SR 161/RIVERSIDE DRIVE ROUNDABOUT OPERATIONS REVIEW APPENDIX

Introduction

Figure 2: Revised Northbound Lane Assignments

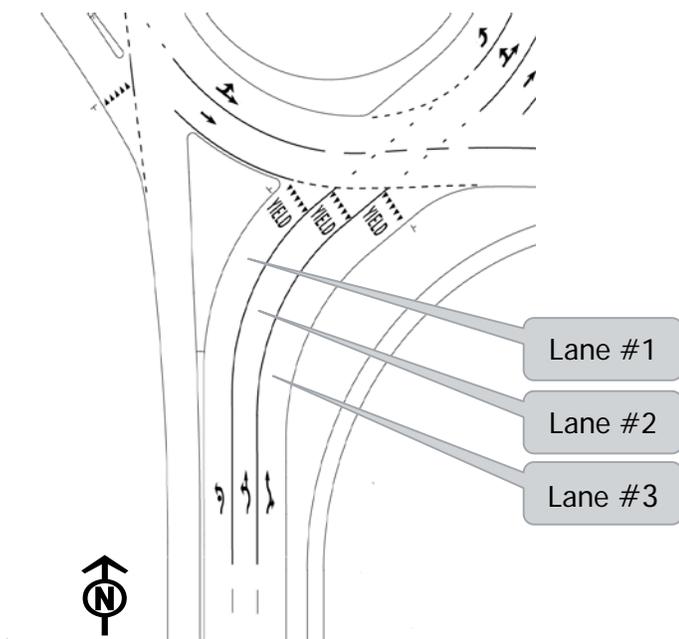
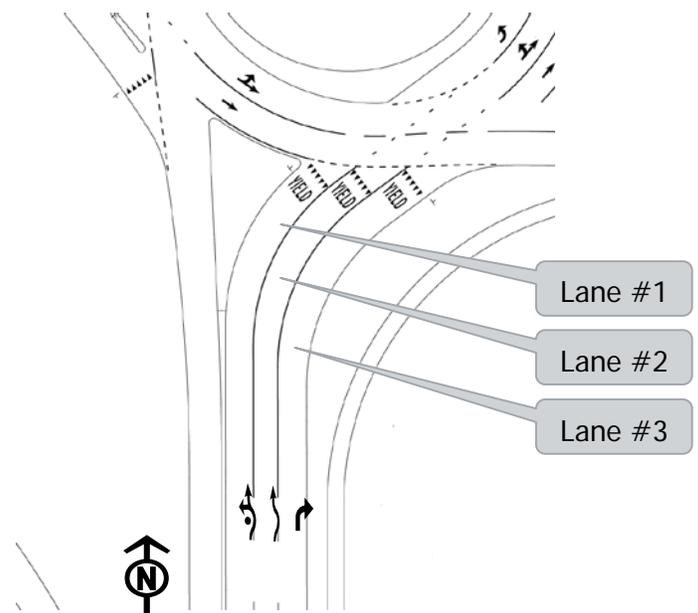
Figure 1 depicts the existing lane assignments for the northbound approach, and the lane numbering nomenclature used. As Figure 1 shows, Lane #1 is a Left Only lane, Lane #2 is a shared Through/Left lane, and Lane #3 is a shared Through/Right lane. Based on field observations, the current lane assignments do not distribute traffic flow evenly across all approach lanes. Lane #1, or the Left Only lane, is underused, which is pushing the movements with the highest volume into Lanes #2 and #3.

Changing the northbound entry lane assignments to the arrangement shown in Figure 2 will have several positive effects on safety performance while still meeting the long range operational requirements. The revised northbound lane assignments are expected to improve these identified issues:

- Simplifies driver decision making on the northbound approach by making lane assignments more intuitive.
- Distributes traffic volumes more evenly over all three entry lanes, improving lane use/balance
- Removes the conflict point (Lane #3 with inside circulating lane) with the highest number of crashes.
- Places the major traffic flow in Lane #1 and Lane #2, where with striping changes, the entry geometry is substantially improved compared to Lane #3.
- Places the right turn volume, which has the lowest volume on the northbound approach, in Lane #3, or the curb lane, which does not circulate in the roundabout.
- Provides a shorter crossing distance into the roundabout for the major traffic flow reducing the necessary decision making time to enter.
- Reduces the number of northbound approach lanes that will potentially conflict with the circulating lanes from three to two.

Based on the sensitivity testing and analysis, the recommended lane assignments are shown in Figure 2 above for the northbound approach.

As Figure 2 shows, Lane #1 becomes a shared Through/Left lane, Lane #2 is a Through lane, and Lane #3 is a Right Only lane. The RODEL analysis with this lane configuration still shows the northbound approach operating very well through the long range (2030) traffic projections.

Figure 4: Existing Pavement Markings

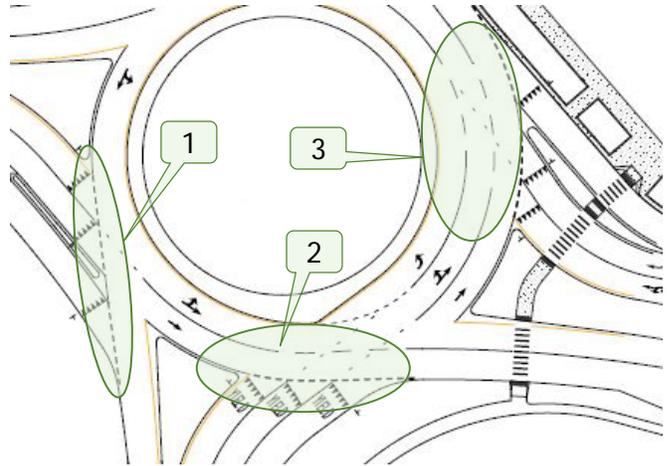
Several pavement marking elements will be modified with the intent to improve driver comprehension relative to the crashes that are occurring. The existing pavement markings that will be improved are listed below and shown on Figure 4:

1. Dotted edge line extended tangent to downstream exit leg contributes to a poor left view angle for Lanes #2 and #3 for the northbound, westbound and eastbound approaches, confusing the priority message of who yields to whom
2. Multiple line types at entry creates information overload and reduces comprehension
3. Varying lane marking types in the circulatory roadway reduces driver recognition of correct lane assignment

Figure 5: Additional set of Pavement Directional Arrows for Westbound Approach

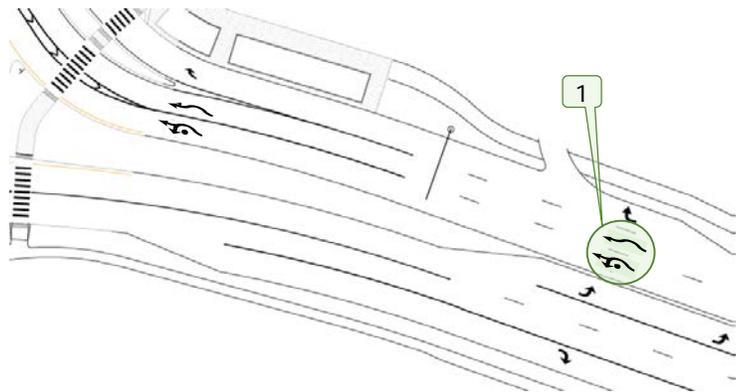
In order to improve driver comprehension, lane discipline, and priority messaging, the following changes will be made to the pavement markings, which are shown in Figure 5 to the right, Figure 6 on page 5, and Figure 7 on page 6:

1. Place an additional set of directional arrows on the pavement for the westbound approach
2. Provide consistent lane assignment markings in the circulatory roadway
3. Provide a 13-foot lane for the inside circulatory lane which will result in a wider outside circulatory lane
4. Modify entry markings on the northbound, westbound, and eastbound approaches to reduce lane widths to 12 feet and align with revised circulatory roadway pavement marking location
5. Remove the shark's teeth and dotted edge line pavement markings at all entries and replace with new bolder yield line placed to clearly delineate yield condition to entry drivers

Figure 6: Proposed Pavement Markings

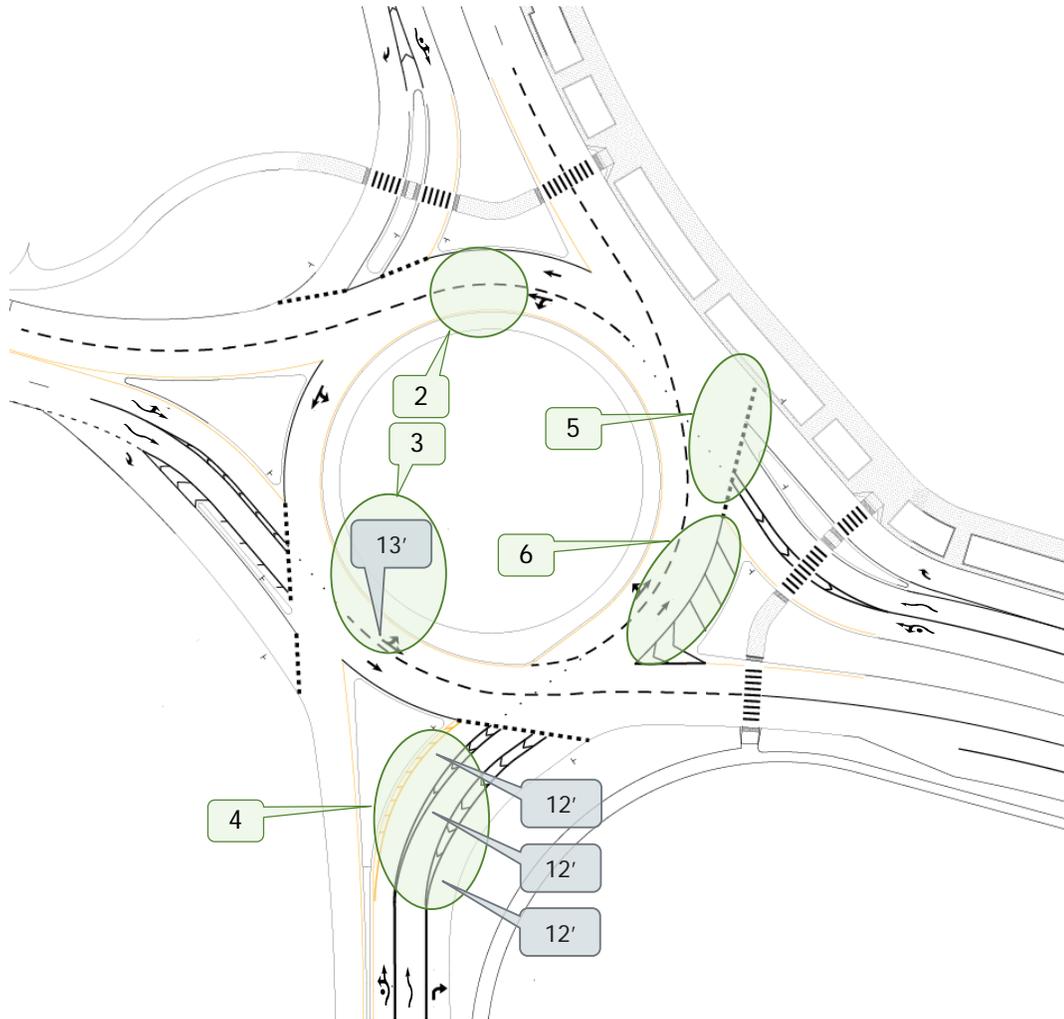
6. Add pavement markings to extend the splitter island on the east side of the roundabout to reflect the proposed northbound Right Only lane. Additionally, reflective raised pavement markers will be installed to define this gore area and reinforce to drivers that this is not an area to be driven on. In the future, granite curb could be added to extend the splitter island to replace the pavement markings. Staff will evaluate if this should be a future upgrade to ensure the roundabout performance and operations have improved.

Figure 7: Northbound Right Turn Only Development/Added Set of Arrows

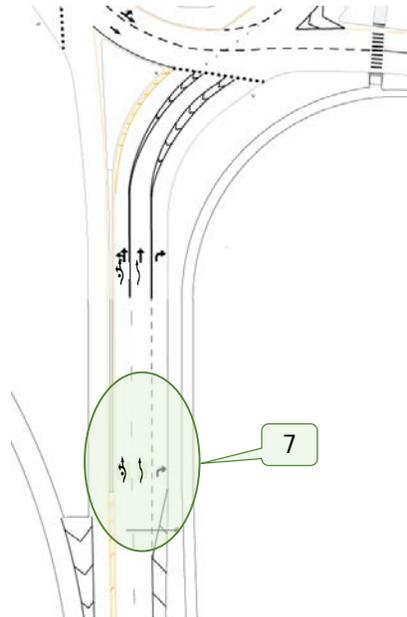
7. Remove the turn lane taper markings for the Left Only lane on the northbound approach and add turn lane taper markings for the Right Only lane and add an additional set of pavement arrows

Figure 8: Full Spiral Removal along Southern Edge of Central Island

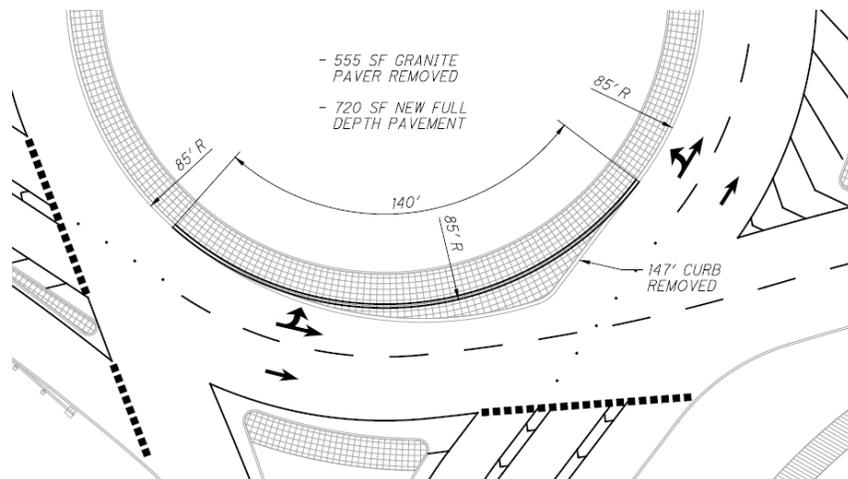
As part of the original design, as shown in Figure 1 on page 2, Lane #1 was a Left Turn Only, and so vehicles making an eastbound left turn were directed to the outside lane on the east side of the roundabout. Now that Lane #1 will become a Shared Left/Through, as shown in Figure 2 on page 2, the curb on the southern side of the central island will be modified in order to simplify the eastbound left turn movement, as shown in Figure 8 below.

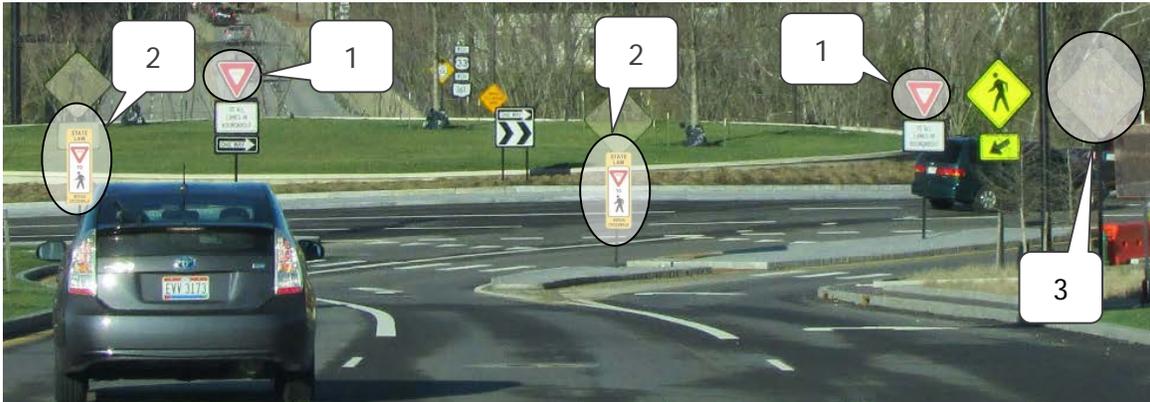
The overhead directional signs in all directions will be modified as follows:

- Install black fishhook arrows on a white background for maximum contrast over the white fishhook arrows and lane indication on the grey background.
- Install an advance lane assignment side-mounted sign to improve driver awareness and to supplement overhead lane use messaging as needed.

The modification provides a simple, clear sign message for better driver comprehension and decision making and will be installed based on feedback received, field observations, and its simple, clear sign message. Staff will continue to monitor the operations and performance of the intersection to determine if the overhead signs should be modified any further to better clarify and simplify sign messaging.
